RESPONSE TO COMMENTS (Referee #2)

Integrating SMART principles in Flood Early Warning System Design in the Himalayas (NHESS-2025-2081)

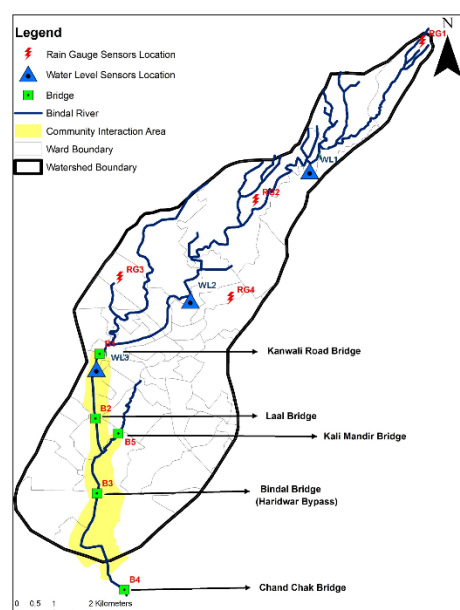
9. Lines 140–145: Including a geographic reference figure in this section would enhance the spatial understanding of the study area and clarify the subdivision of the river segments. At present, Figure 3 provides only partial information, and its placement far from the relevant text reduces its immediacy and readability.

Thank you for this helpful suggestion for improving spatial clarity in the manuscript. We agree that including a geographic reference figure closer to lines 140–145 would enhance the understanding of the study area. In response, we have updated Figure 3 to more comprehensively illustrate the locations and boundaries of the relevant river stretches and reposition the figure in section 3.1 nearer to the corresponding text section to improve immediacy and readability. A direct reference to Figure 3 will also be added in lines 140–145 to guide readers efficiently to the spatial context.

The updated figure can be found in the revised manuscript (Figure 3).
